**RE: Item H-2, City Council Hearing February 5, 2018;  
Appeal of Breakers Hotel Project (SPR18-033, CUP18-015, LCDP18-022, CE18-152);  
Appellant's Response to Staff Report & Other Submissions**

Report of Potential Noise Impacts of Breakers Hotel Project  
210 East Ocean Boulevard, Long Beach, CA; Application No. 1806-19

**Figure 1: 2<sup>nd</sup>, 3<sup>rd</sup>, & 14<sup>th</sup>-Level Roof Decks (Simulated View Showing Proximity to Neighboring Apartments)**

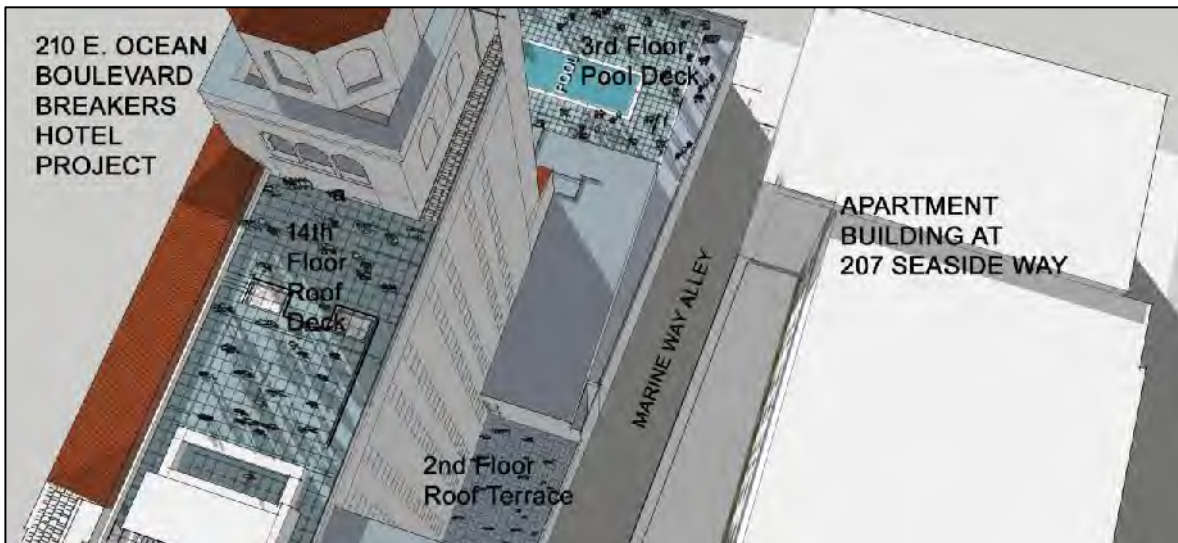
These outdoor areas could include major sources of noise, such as small and large crowds including large events, parties, gatherings, people talking with raised voices, pool use, deck and pool bar use with alcohol service, and possible musical performances (amplified music). No restrictions prohibit these activities beyond compliance with the City’s noise standards (i.e., COA-29). However, as discussed herein, noise from these outdoor activities will significantly impact neighboring apartments currently being constructed at 207 Seaside Way with their bedroom windows located across the alley only about 20 feet away from the Project’s 3<sup>rd</sup>-level decks, and 28 feet away from the 2<sup>nd</sup>-level decks (as depicted in the Figures 1-5 below and on the following page).<sup>11</sup>

Unlike other projects reviewed by the City,<sup>12</sup> the *Project applicant has not submitted any noise measurements of existing ambient noise levels or evidence that compliance with the City’s noise standard (COA-29) is even possible*. Such measurements and analysis are critical if the City is to protect nearby residential neighbors from adverse sleep-disturbing impacts from new hotel noise sources. Absent meaningful and credible noise measurements, the LBMC’s general and music/speech-specific ambient noise levels must be presumed.

**Figures 2-3: 2<sup>nd</sup> & 3<sup>rd</sup>-Level Rooftop Plan (Showing Proximity to Neighboring Apartments)**

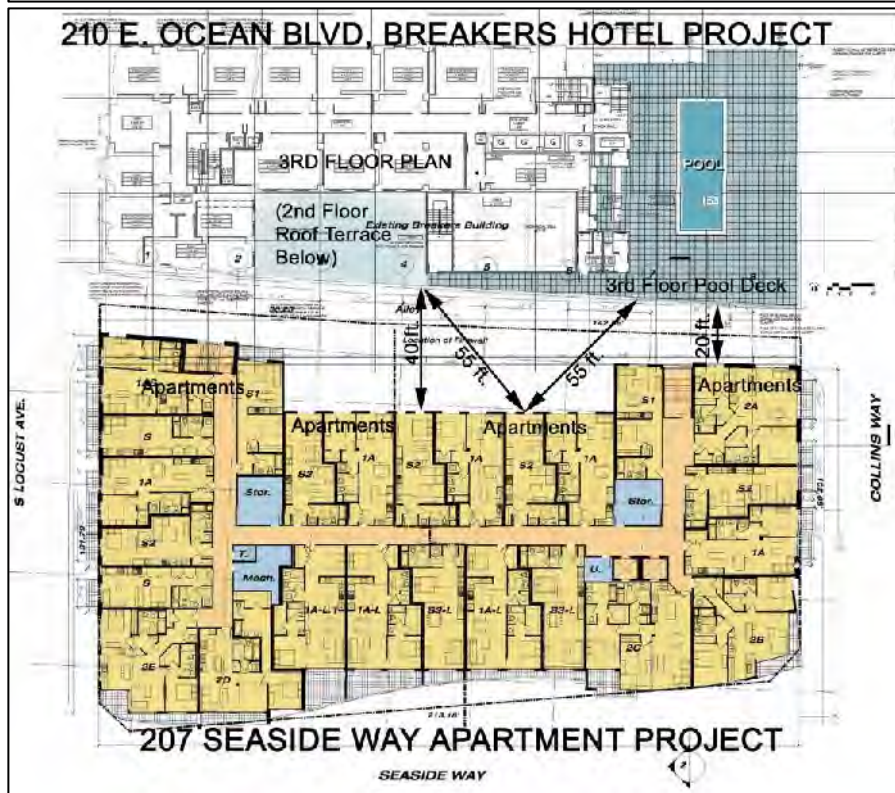
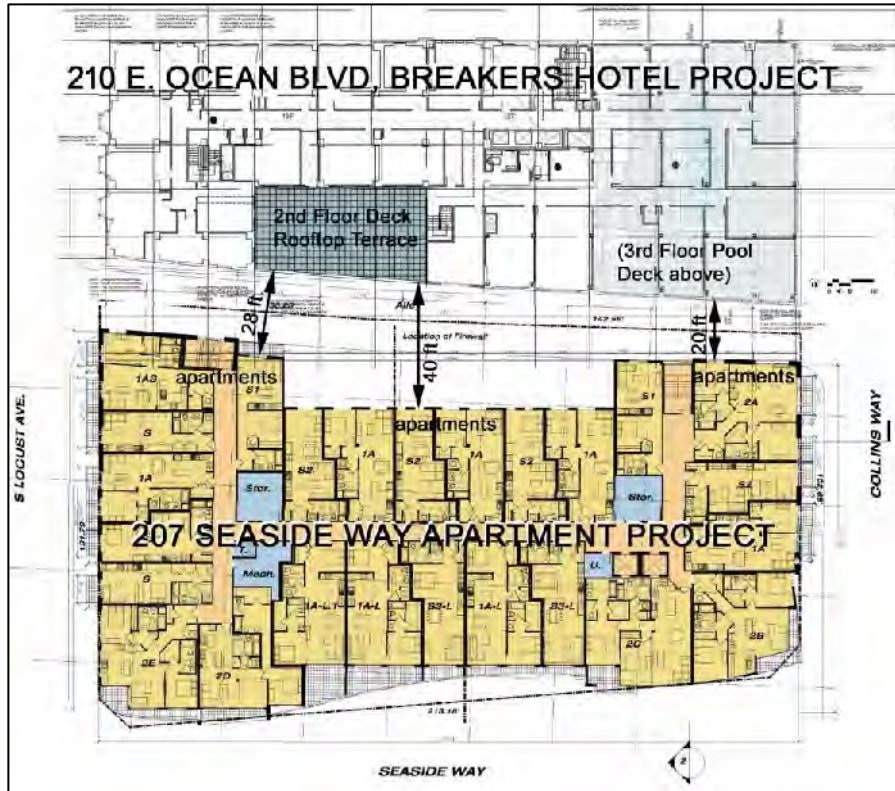
- 2<sup>nd</sup>-level rear roof with an open terrace area and stairwell to access the 3<sup>rd</sup>-level pool deck;
- 3<sup>rd</sup>-level roof with a new rooftop pool with a deck and pool bar; and
- 14<sup>th</sup>-level rooftop terrace area would be expanded by approximately 1,815 feet.

**Figure 4: 2<sup>nd</sup>-Level Roof Terrace (Simulated View Showing Proximity to Neighboring Apartments)**

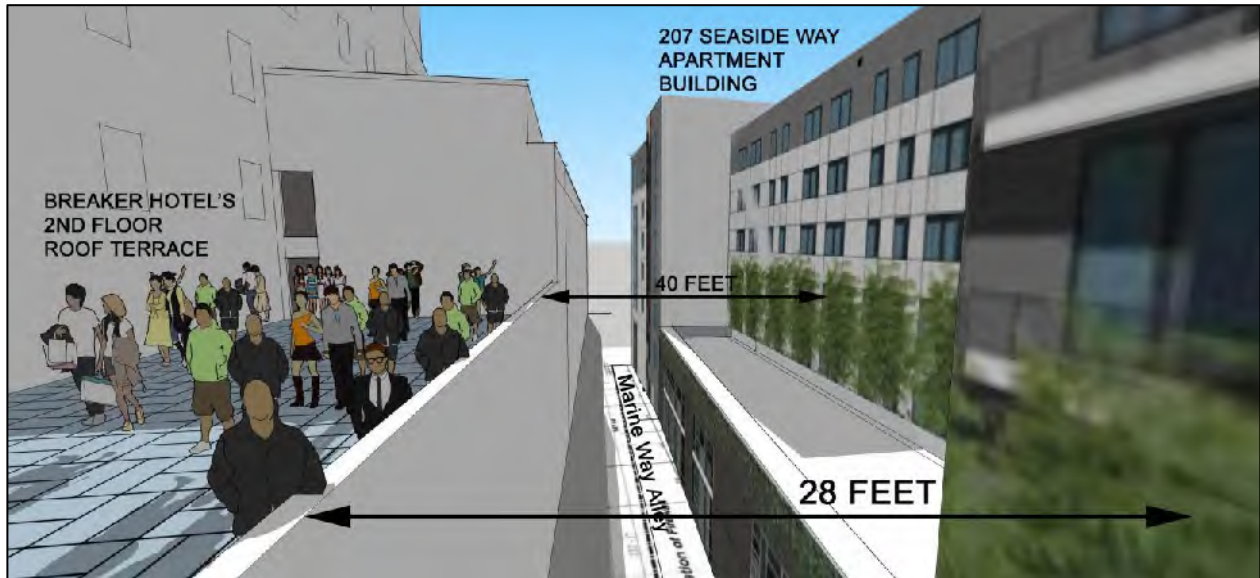
As previously discussed, the 2<sup>nd</sup>-level outdoor terrace is 28 feet from the nearest apartment unit at the 207 Seaside Way project with an occupancy load of 113 people (see Figure 12 below). Utilizing the same referenced noise levels discussed above for this 2<sup>nd</sup>-level area, several people speaking would cause a 53.6 dBA noise impact,<sup>40</sup> a single group of 24 people speaking simultaneously would create a 64.5 dBA noise impact,<sup>41</sup> and amplified music would create an 84.5 dBA noise impact.<sup>42</sup>

**Figure 5: 3<sup>rd</sup>-Level Pool Deck (Simulated View Showing Proximity to Neighboring Apartments)**

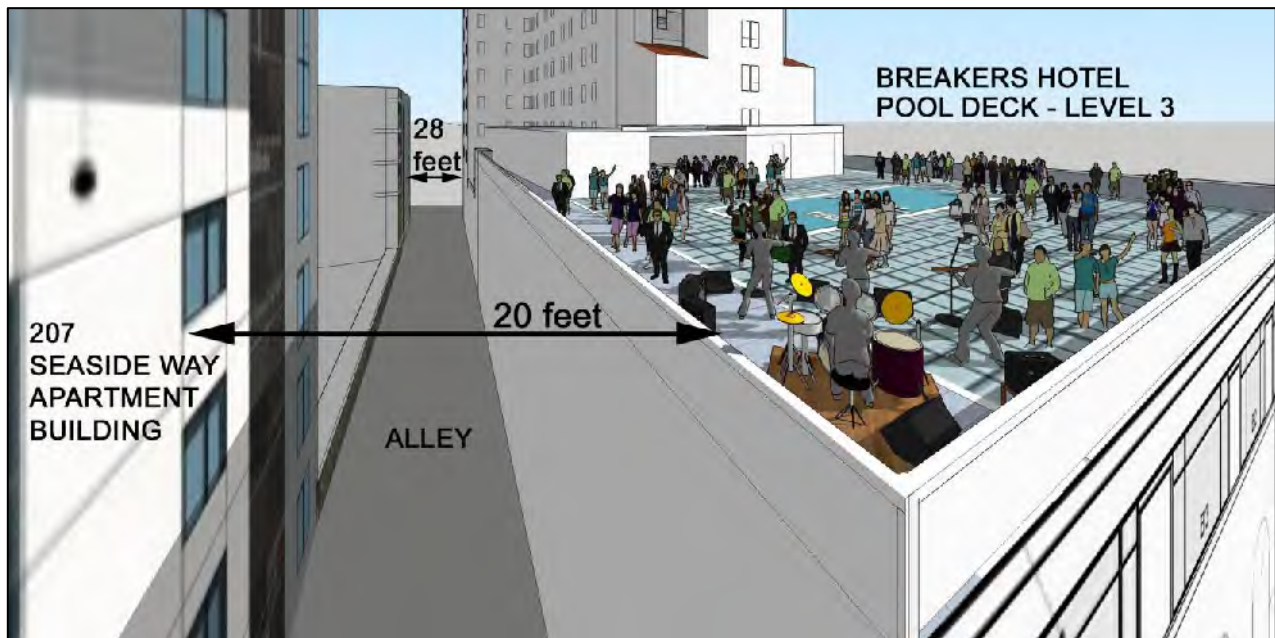
The noise level from several people speaking outdoors at average voice levels can exceed 73 dBA at a distance of 3 feet.<sup>13</sup> As compared to typical residential uses where residents have a vested interest to monitor their outdoor noise volumes (e.g., talking on front porches heard by adjacent homes), hotel guests have little reason to keep their voices down and respect neighbors at night because their stays will be short-term and they will not know these neighbors. At as close as about 20 feet to the neighboring apartment units, such vocal noise levels would reduce to about 56.5 dBA  $L_{eq}$ ,<sup>14</sup> which will exceed both the City's assumed 55 dBA daytime and 50 dBA nighttime ambient noise limits for music/speech.<sup>15</sup> Hence, the vocal noise impacts from the 3<sup>rd</sup>-level deck usage by just several people, even without music or a larger crowds, could be 6.5 dB above ambient levels in the nighttime<sup>16</sup>—and thus greater than the 5-dB threshold under the City's standards when adjusted with the 5 dB penalty for speech.

There are no proposed COAs or applicable City regulations to prohibit nighttime use at any hour of the exterior rooftop decks at this Breakers Hotel Project. Only COA-29 would possibly limit the loudness of “noise levels emanating from the Project's common outdoor areas (rooftop terrace, outdoor pool deck, etc.) [to] not exceed applicable noise standards specified in Long Beach Municipal Code Section 8.80.15 – Exterior Noise Limits.” But those standards are not sufficient to mitigate Project noise impacts at neighboring apartment units to less-than-significant. For example, Section 8.80.15 allows noise levels after 10:00 p.m. of up to 55 dBA  $L_{eq}$  for noise that exceeds 30 minutes during an hour. It is likely that people will talk for more than 30 minutes in an hour on these exterior decks. Neither the Project applicant nor the City suggest how hotel guests will be prevented from conversing outdoors on a rooftop terrace or pool deck if noise level exceed this noise standards. Nor does the City propose limiting the total people to occupy this area. Therefore, several people speaking at the southern edge of the rooftop pool deck near these apartments with a vocal noise level of 56.5 dBA  $L_{eq}$  would exceed City standards and cause an increase in ambient noise levels there of more than 5 dBA – and, thus, a significance impact.

Accordingly, even with just several people talking outdoors, the Project's outdoor 3<sup>rd</sup>-level pool deck use could generate noise levels at neighboring apartment units that would exceed typical CEQA numeric limits and be significant, despite COA-29's noise levels restriction. That adverse noise impact increases significantly with larger crowds or with music played on these rooftop decks (as discussed in the below sections).

**Figure 9: 3<sup>rd</sup>-Level Pool Deck Plan (Five Groups of People Under Possible Crowded Conditions as Measured to Nearest Apartments)**

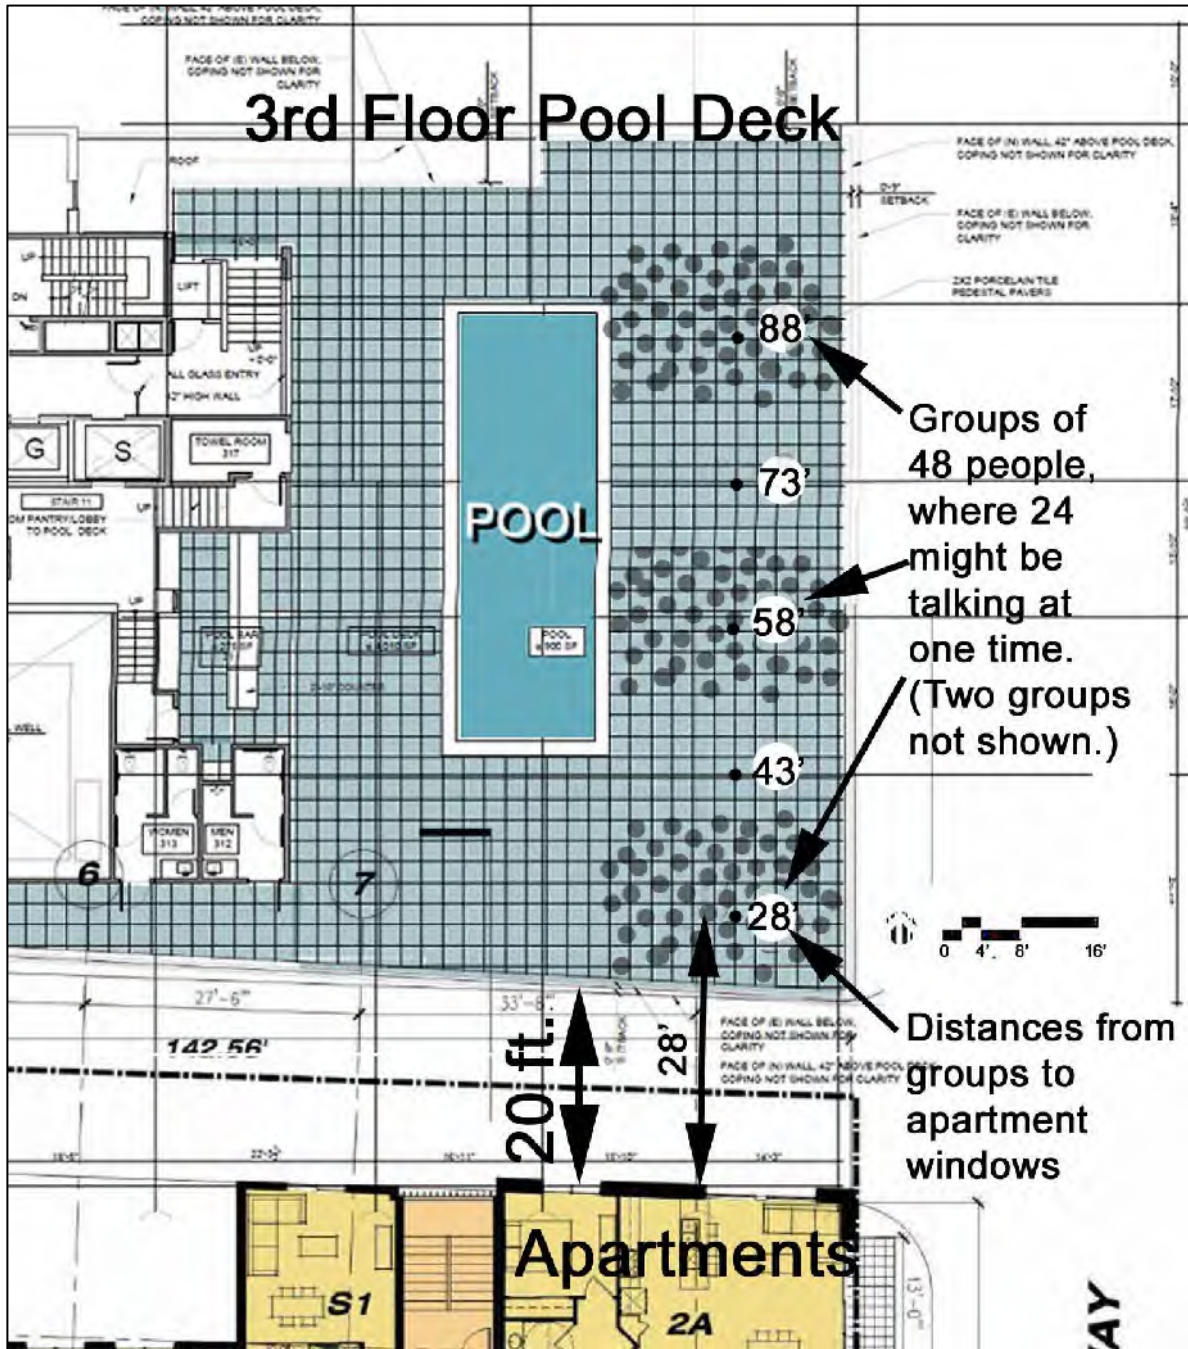
If the maximum size crowd is spread out more in an east-west direction than illustrated above (i.e. left and right) but at similar distances to the apartments, their combined vocal noise levels as measured at the apartments would be similar to the calculation below.

To calculate how loud a possible crowd could be when measured at the nearest apartments, one would calculate and then logarithmically add the volumes of these groups of people. If a single person speaks in a crowd at an average loud voice level 73 dBA at 3 feet, then at a distance of 28 feet (the distance to the nearest apartment window to the south), the person's vocal noise level would be about 53.6 dBA.<sup>28</sup> However, if 24 people are speaking simultaneously there at the same volume, their combined voice levels would be about 67.4 dBA at a distance of 28 feet.<sup>29</sup> Similarly calculated, the noise levels from the second group of 24 simultaneously-speaking people would be about 63.7 dBA at a distance of 43 feet;<sup>30</sup> for the third group, about 61.1 dBA at a distance of 58 feet;<sup>31</sup> for the fourth group, about 59.1 dBA at a distance of 73 feet;<sup>32</sup> and for the fifth group, about 57.4 dBA at a distance of 88 feet.<sup>33</sup> When logarithmically combined, noise levels of all five groups would be about 70.2 dBA at the nearest apartment windows.<sup>34</sup>

**Figures 10: 3<sup>rd</sup>-Level Pool Deck (Simulated View of Possible Live Music and Apartments as Close as 20 Feet Away)**

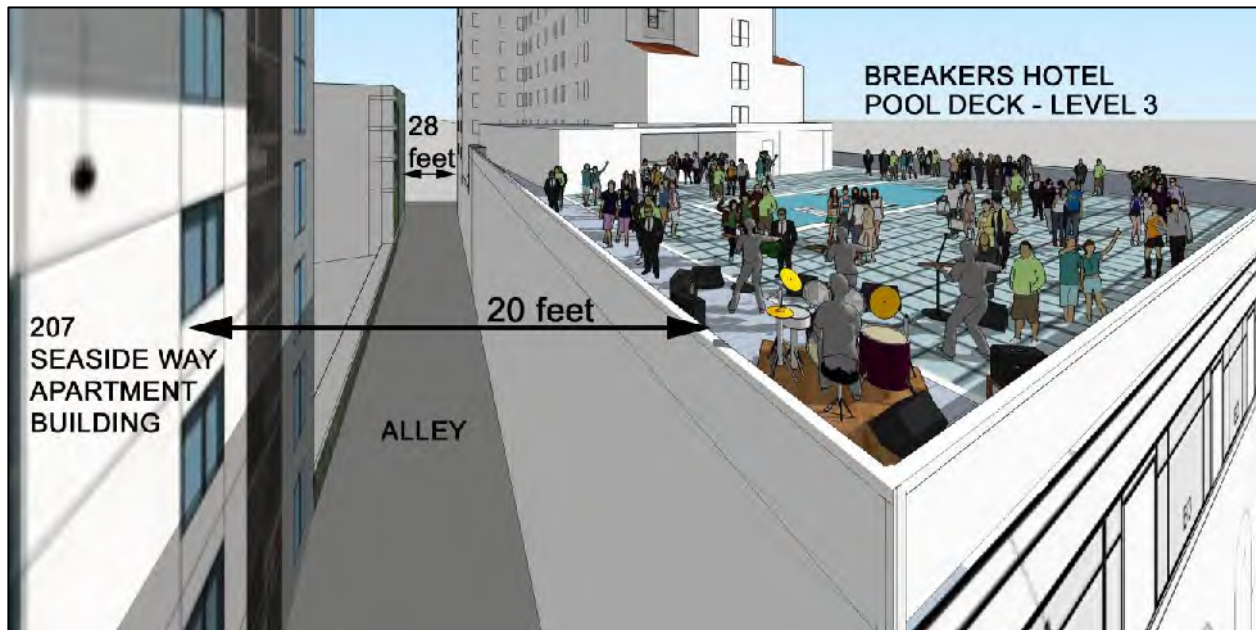
This Project includes possible ambient music or even musical performances (amplified music) on its three exterior rooftop patios or decks.<sup>37</sup> The nearest apartment windows are as close as only 20 feet, so significant noise impacts from music are even more likely than from voices. Music in such hotel settings is sometimes played louder than people’s voices so it can be heard above the din of conversations.

**Figure 12: 2<sup>nd</sup>-Level Terrace Deck (Simulated View Showing Proximity to Apartments)**

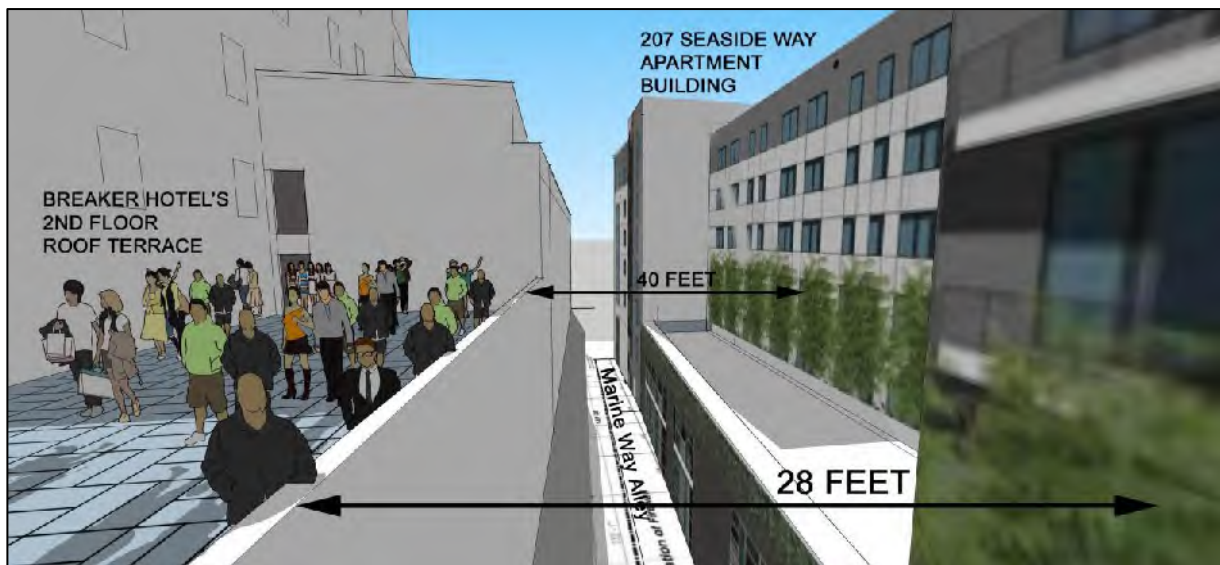
However, these apartments will be exposed to higher noise levels than would be predicted by distance attenuation alone. That extra noise would be added to those sound waves that directly radiate from the 2<sup>nd</sup>-level rooftop terrace deck activities, such as voices, crowd, and amplified music that will reflect off the hard surface of the Hotel's tower façade and will bounce back to the apartment units to the south (see Figure 12 above). It is well known to urban planners that:

To be conservative, at least 1 dB would be added to the small/large crowd noise and amplified music noise that bounce off the southern Hotel facade and reflect back onto those nearby apartment units.<sup>45</sup> Hence, several people speaking will cause a 54.6 dBA noise impact, a single group of 24 people speaking simultaneously would create a 65.5 dBA noise impact, and an amplified sound system would create an 85.5 dBA noise impact. Again, these noise levels would exceed various exterior noise standards under the LBMC and exceed the 5 dBA increase threshold, without even considering the cumulative effect of these activities occurring at the same time, nor consideration of other noise sources (e.g., 3<sup>rd</sup>-level outdoor activity, the building’s HVAC equipment, etc.).
